SERVICE BULLETIN

N° **189-376**

**ATA 06 – ENGINE CABLE ASSY RE-ROUTING**

This Service Bulletin is issued in order to provide the necessary instruction on how to perform the “engine 1/2 CTRL & IND C/A installation retromod” P/N 8G0630P09011.

**ENGINE 1/2 CTRL & IND C/A INST. RETROMOD**  
**8G0630P09011**

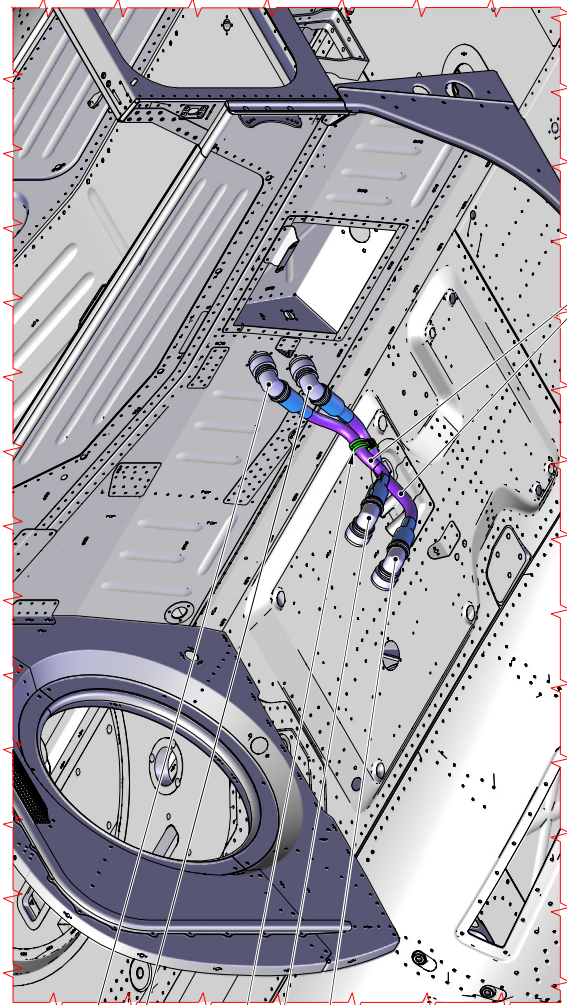
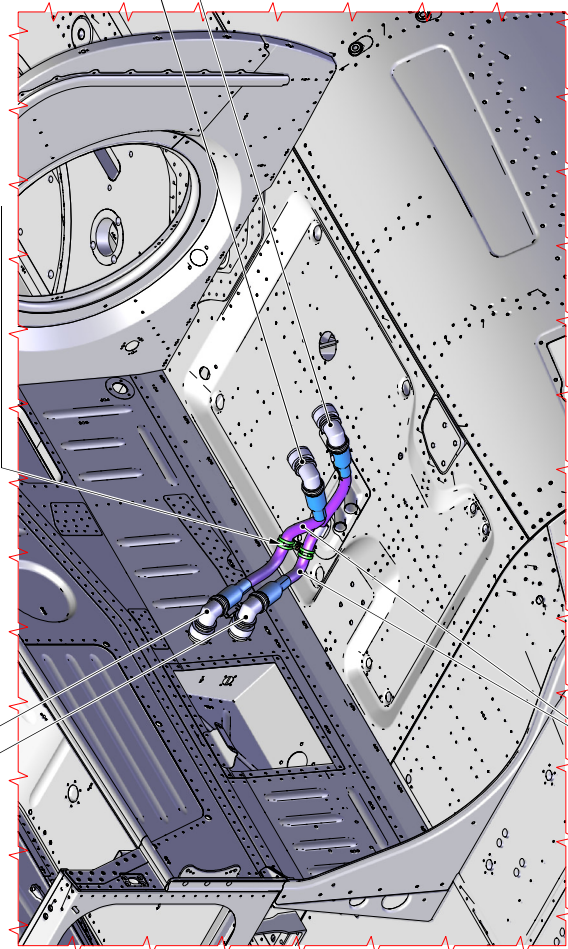
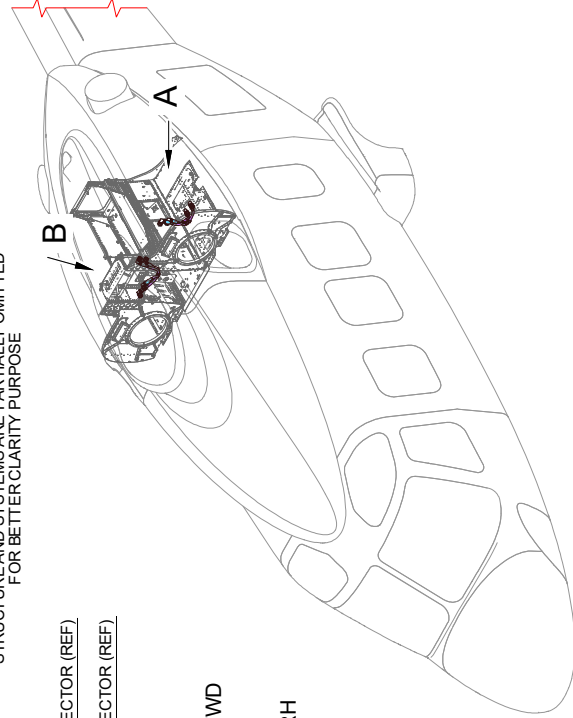
This Service Bulletin provides instruction on how to install fixing points on the C/As in the upper deck engine area to modify the routing in order to avoid possible interference between the harnesses connecting the engine FADEC and the firewall.

- 2.1 With reference to Figure 1 View A and in accordance to AMP DM 89-A-71-01-01-00A-520A-A, remove the Number 1 engine to gain access to the LH upper deck.

- 2.2 With reference to Figure 1 View A, re-route the engine 1 CTRL & IND cable assemblies as shown.
  - 2.3 With reference to Figure 1 View A, install n°2 clamps P/N AW001CB11H on the engine 1 CTRL & IND cable assemblies and fix by means of one screw P/N NAS1802-3-8, n°2 washers P/N NAS1149C0316R and the nut P/N MS21043-3.

- 2.4 In accordance to AMP DM 89-A-71-01-01-00A-720A-A, re-install the Number 1 engine.
  - 2.5 With reference to Figure 1 View B and in accordance with AMP DM 89-A-71-01-02-00A-520A-A, remove the Number 2 engine to gain access to the RH upper deck and repeat steps 2.2 and 2.3 for the RH upper deck to re-route the engine 2 CTRL & IND cable assemblies.

- P267 CONNECTOR (REF)
- P265 CONNECTOR (REF)
- INSTALL:  
AW001CB11H CLAMP (QTY 2)  
NAS1802-3-8 SCREW  
NAS1149C0316R WASHER (QTY 2)  
MS21043-3 NUT
- A11P2 CONNECTOR (REF)
- A11P1 CONNECTOR (REF)

- INSTALL:  
AW001CB11H CLAMP (QTY 2)  
NAS1802-3-8 SCREW  
NAS1149C0316R WASHER (QTY 2)  
MS21043-3 NUT

RE-ROUTE AS SHOWN,  
ENGINE 2 CTRL & IND C/A
